ADDENDUM

Forestside Estates
Attmar & Palleschi Drive
Brampton, Ontario
Attn: **Vince Staffieri**

AM 08

PROJECT	**: Forestside**
PROJECT #	**: 1331.15**
DATE	**: Jan 18, 2021**

KEY PLAN

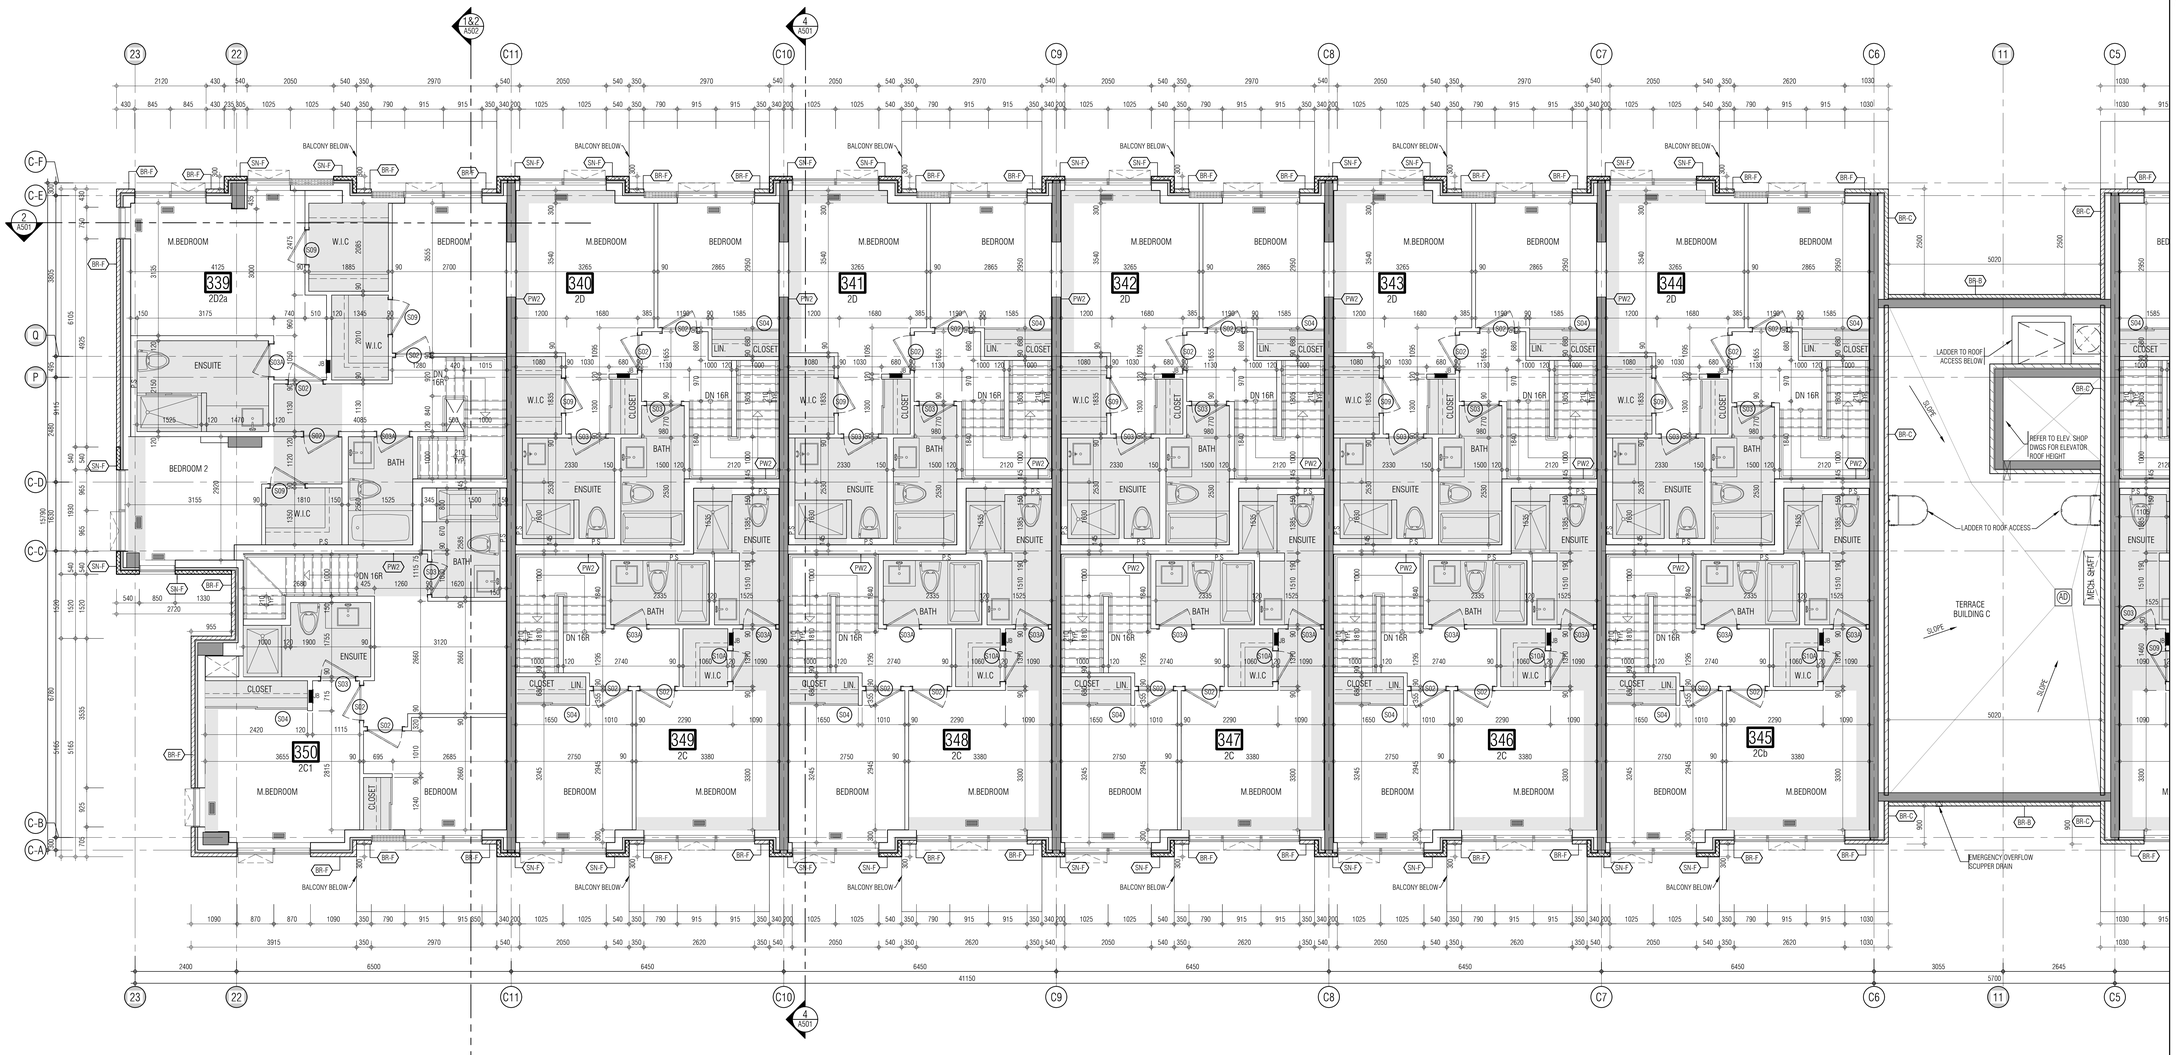
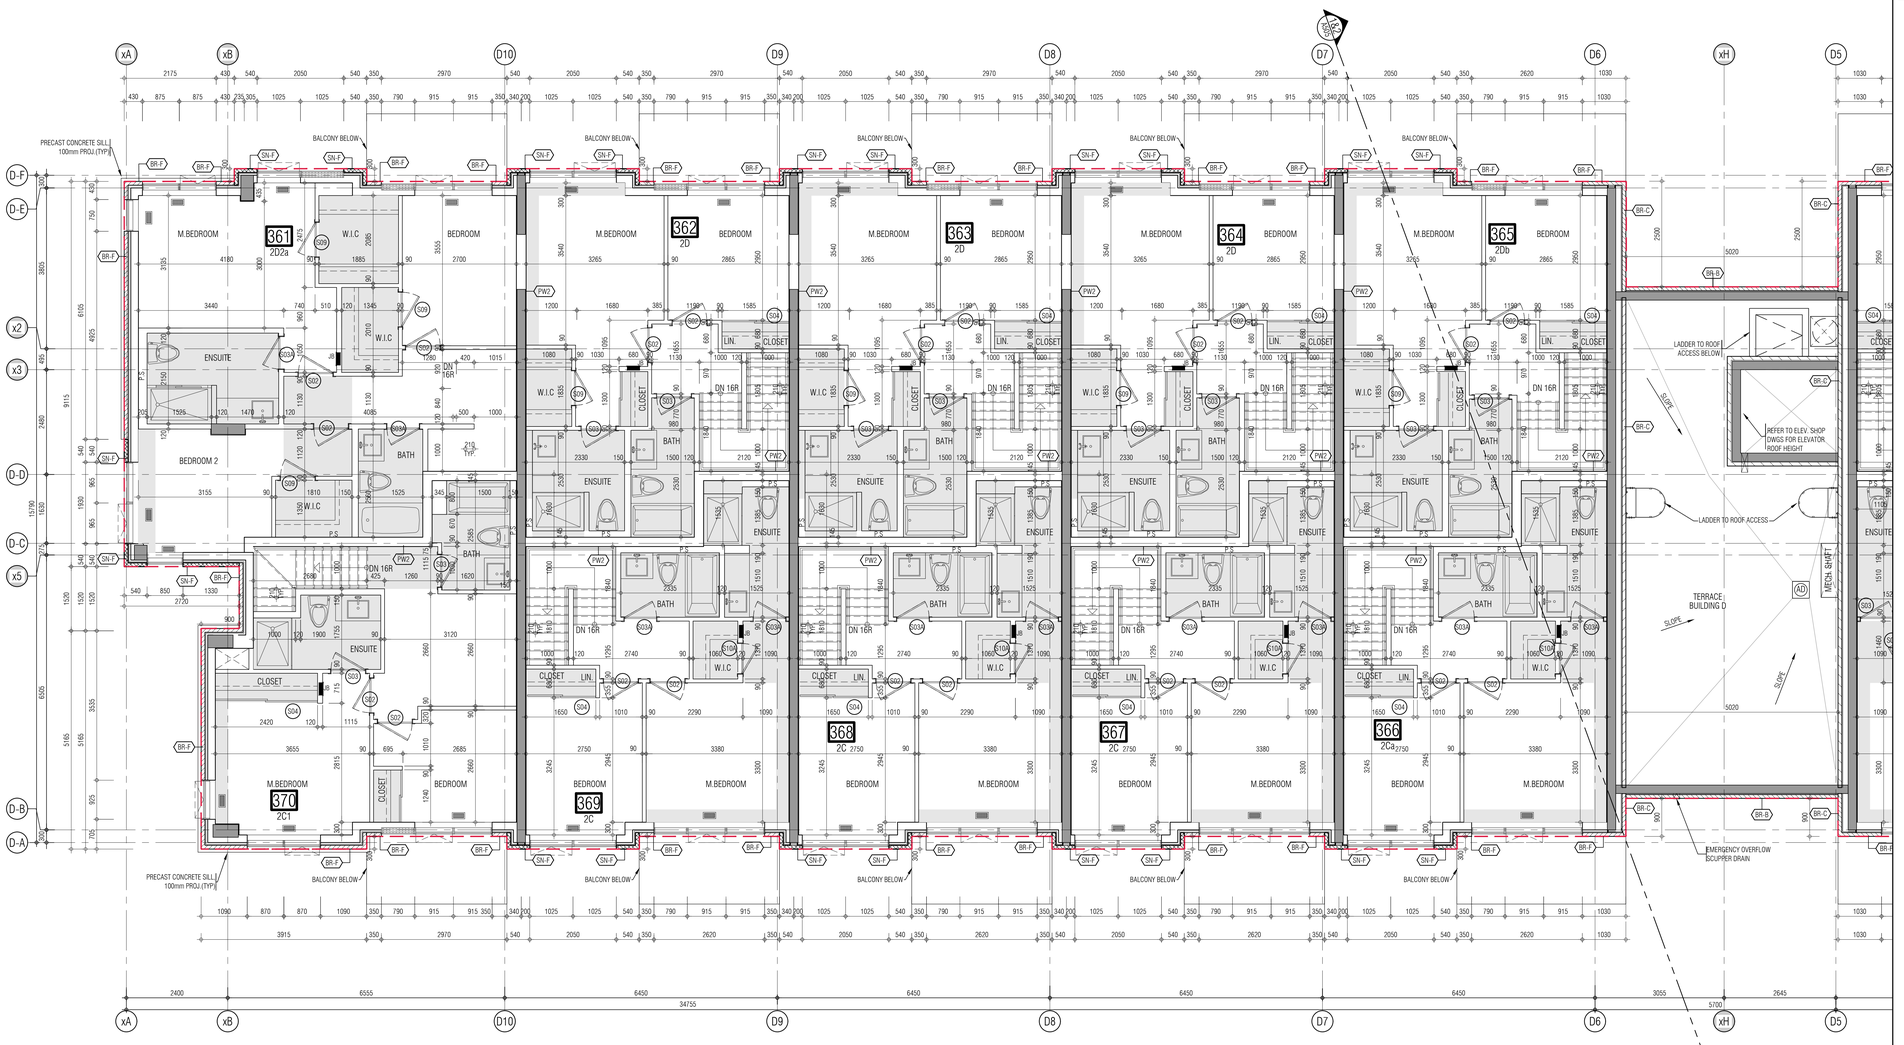
A301-A304	1st – 4th Floor Plans	• Move Blocks A and B north 286mm to comply with 0.3m easement and 3.0m minimum set back to property line as per clients request. • Move Block D up 390mm along angle north to comply with 0.3m easement and 3.0m minimum set back to property line as per clients request.
A701a-A701b	Stair Sections	• Revised dimensions on stair plans to match blocks that were moved.
